PHO M2799

**PACIFIC HIGHWAY UPGRADE SAPPHIRE TO WOOLGOOLGA PROJECT
PROPOSED MODIFICATION OF THE PROJECT APPROVAL**

The Roads and Maritime Services (RMS) are requesting a modification of the project approval for the Sapphire to Woolgoolga Pacific Highway upgrade project to incorporate a rest area at Arrawarra.

Figure 4: Structure of MUSIC modelling used for assessment of stormwater treatment performance of Scenario 4.

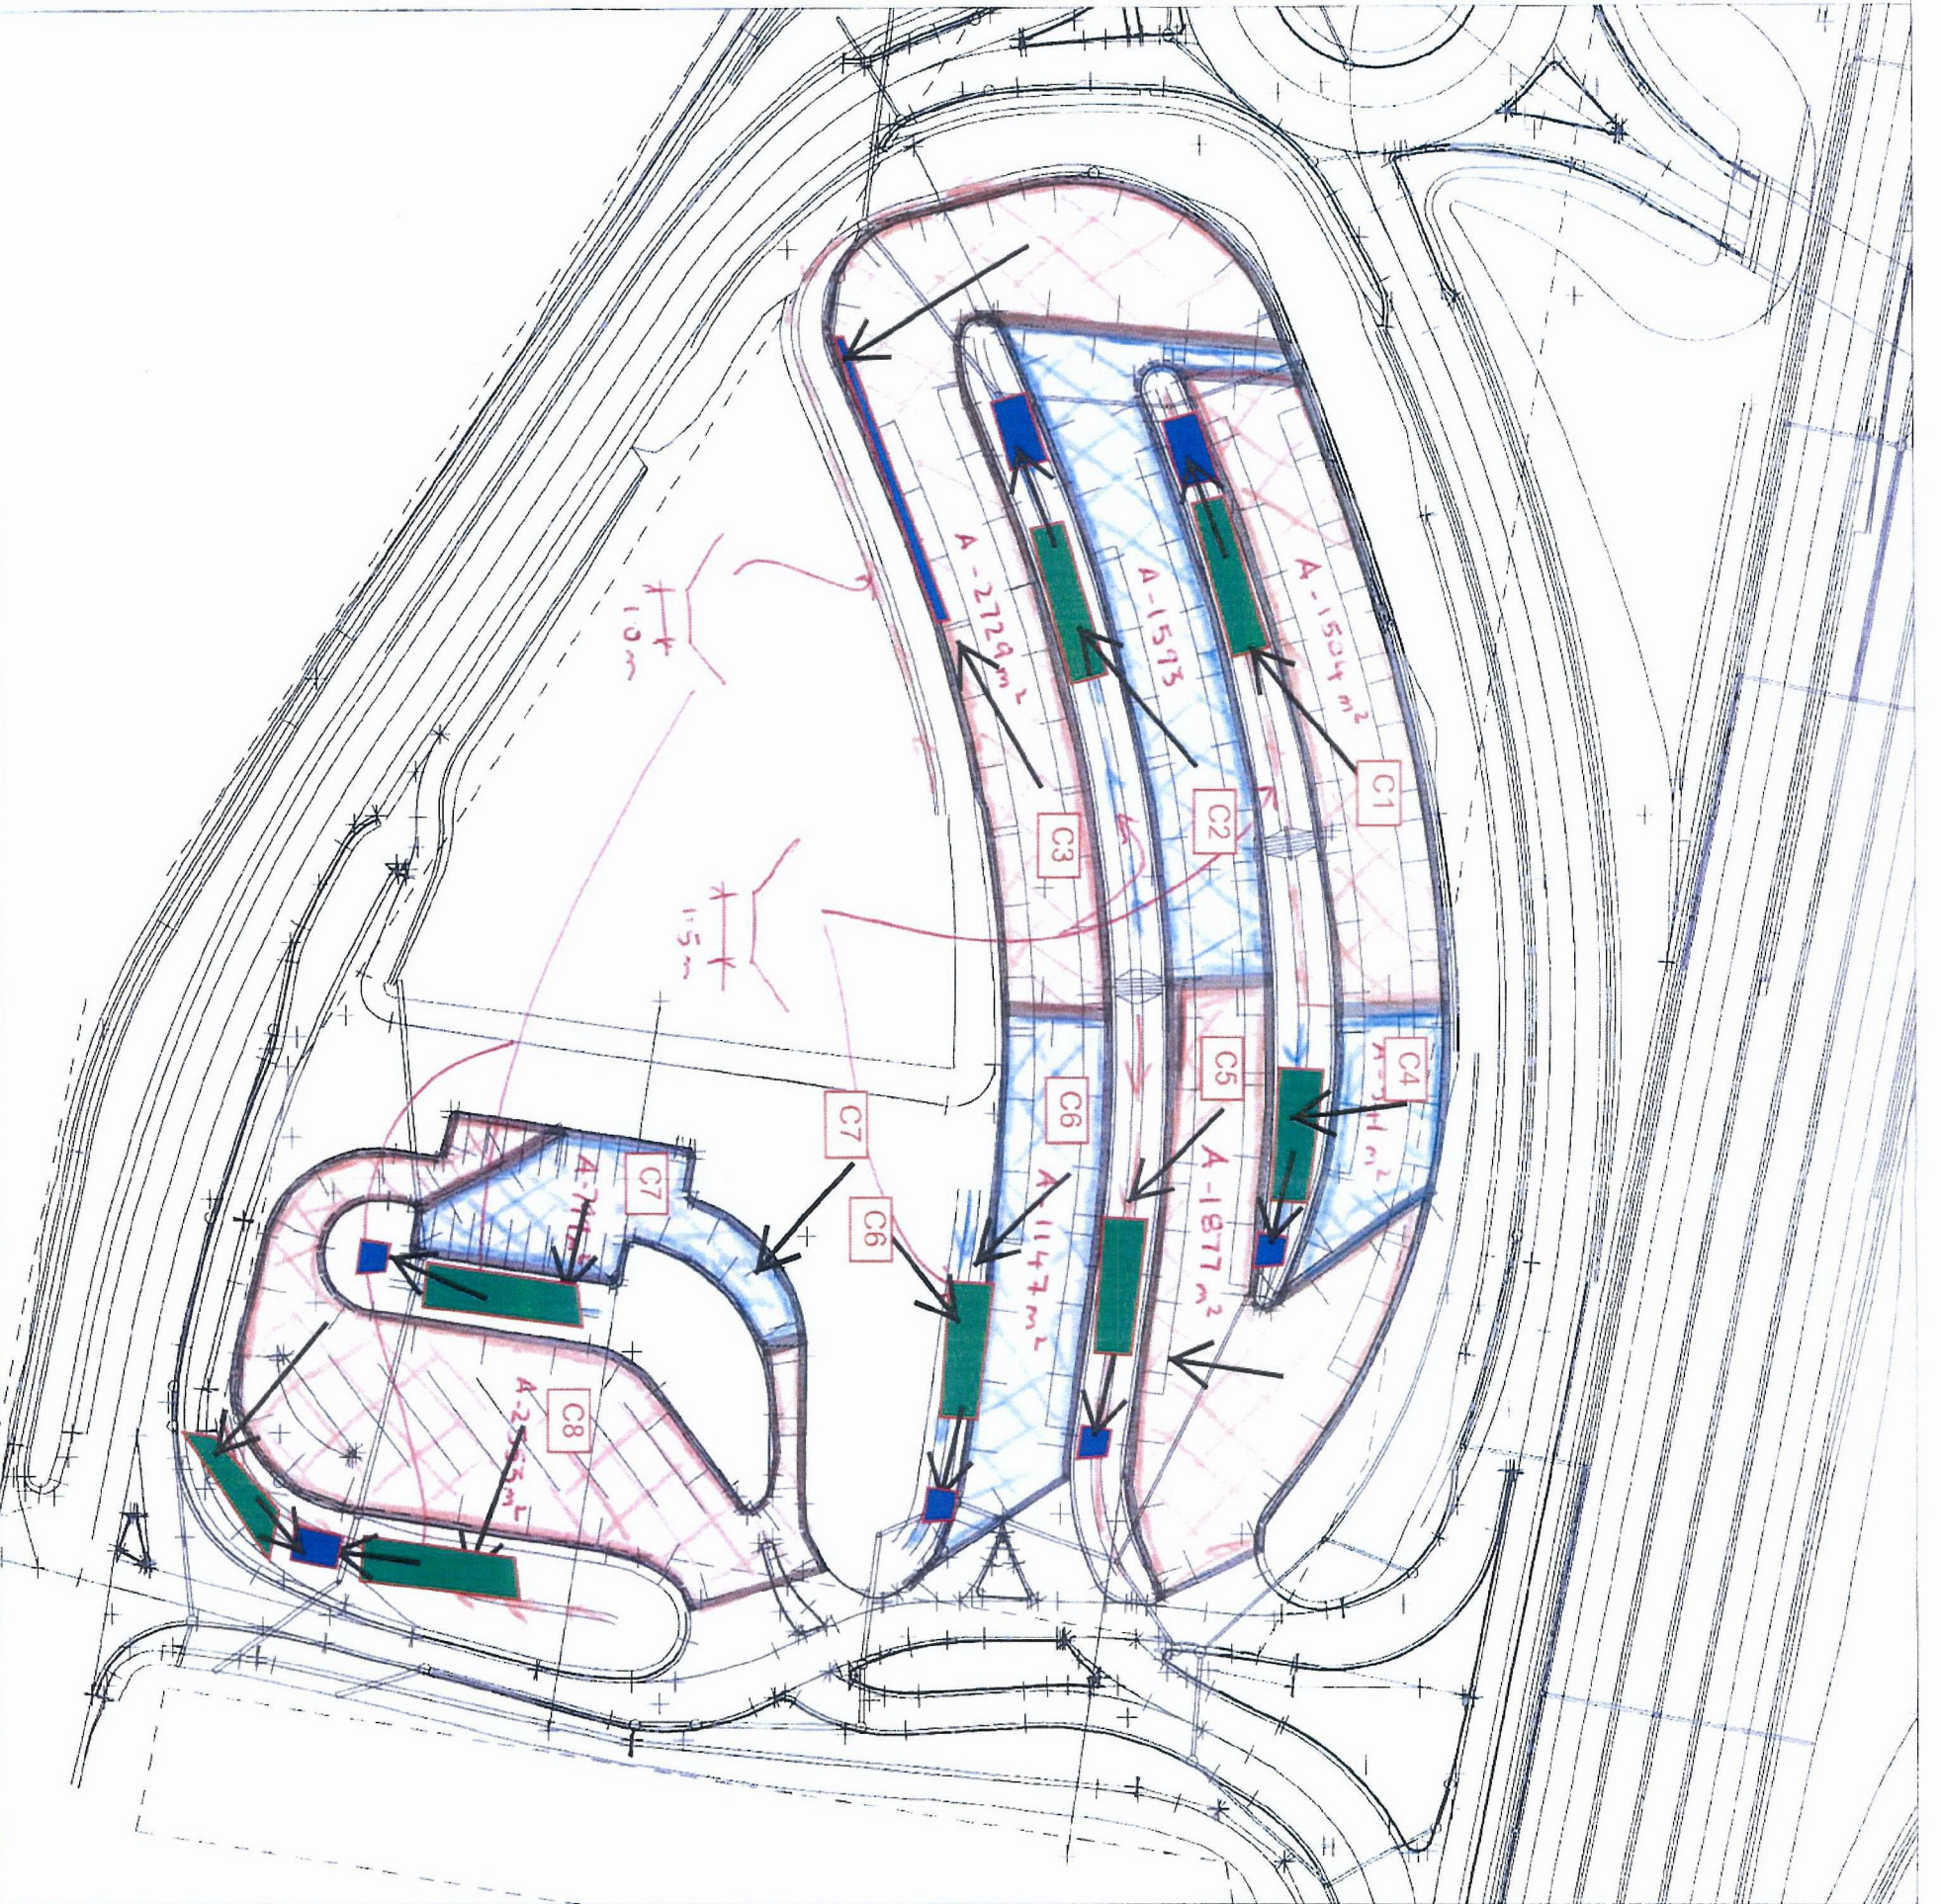
Following the initial investigations for Scenario 3, the earthworks and stormwater drainage designs were revisited to determine if it would be possible to treat all catchments. This investigation revealed that it is feasible to treat all catchments; however the catchment boundaries and subsequent water quality modelling needed to be updated. Table 5 includes the swale and bioretention areas that were included in this assessment of all potential treatment opportunities. The updated catchments are illustrated in Attachment B and Figure 4.

Therefore in order to provide treatment of runoff sufficient to meet the NSW guideline targets, a comparatively larger total surface area of bioretention systems is required for Scenario 4 compared to Scenario 2. Scenario 4 demonstrates that a total bioretention surface area of 197m² is required to provide sufficient nitrogen removal to reach the treatment targets.
